Rezoning Transportation Analysis

Petition Number: #2022-050

General Location Identifier: 16303248

Date	Description
08-11-2022	First Review (WB)
09-21-2022	Second Review (JC)

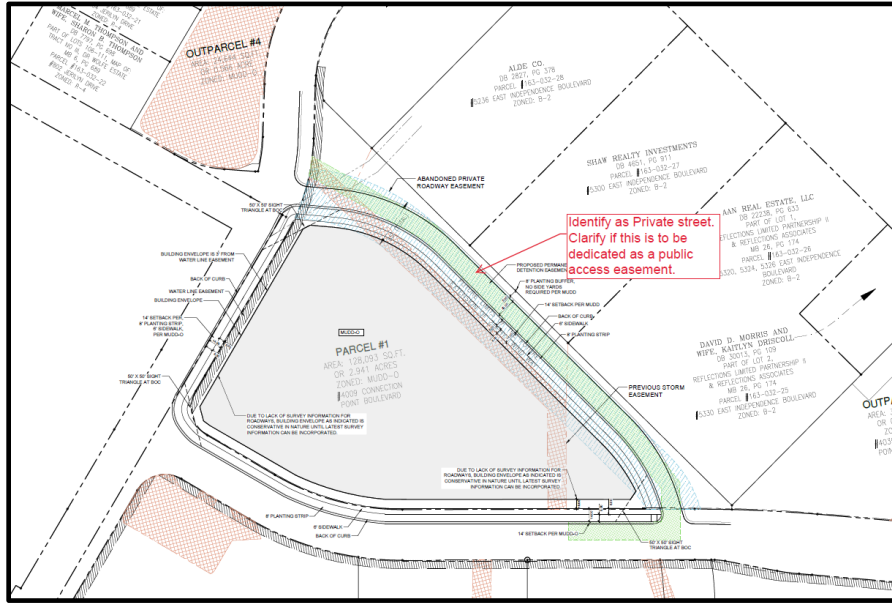
Label and dimension the curb and gutter from the centerline for each road on the site plan.

A Traffic Impact Study (TIS) is not necessary for the complete review of this petition due to the site generating less than 2,500 daily trips. If during the permitting process the site generates more than 2,500 daily trips, then a traffic study will be required.
